| Category P | Technical | Ref. No. E005/18A | Page 1 of 2 |
| Applicable Model CX-5 (KE/KF) and CX-9 (TC) with Electric Parking Brake | | Applicable Countries and/or Vehicle Specifications Worldwide | |

Subject: Caution when performing Electric Parking Brake (EPB) Forced Release

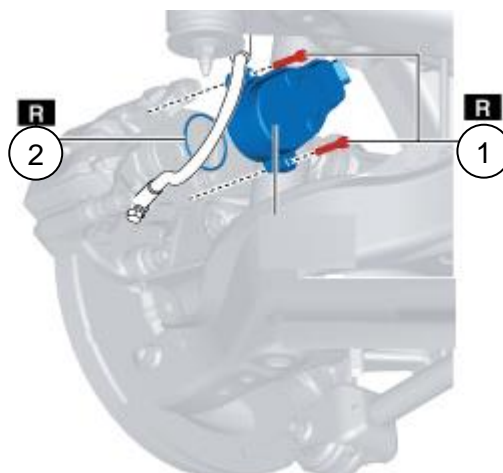
DO NOT release the spindle too much.

Rotate the spindle (1) only **one (1) turn** in the direction of the arrow shown in the figure.

If the spindle is released too much beyond one (1) turn, replace the brake caliper with a new one since the brake caliper may be damaged.

Although the Workshop Manual "ELECTRIC PARKING BRAKE FORCED RELEASE PROCEDURE" instructs to rotate the spindle approx. 2-3 times, this is wrong information and it will be corrected soon.

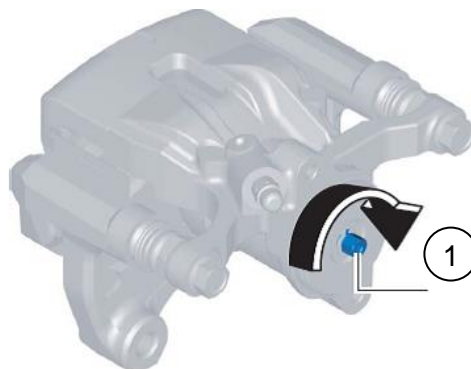
DO NOT reuse parts marked [R]

Replace two bolts (1) and O-ring (2) with new ones when reinstalling the EPB Motor Gear Unit.
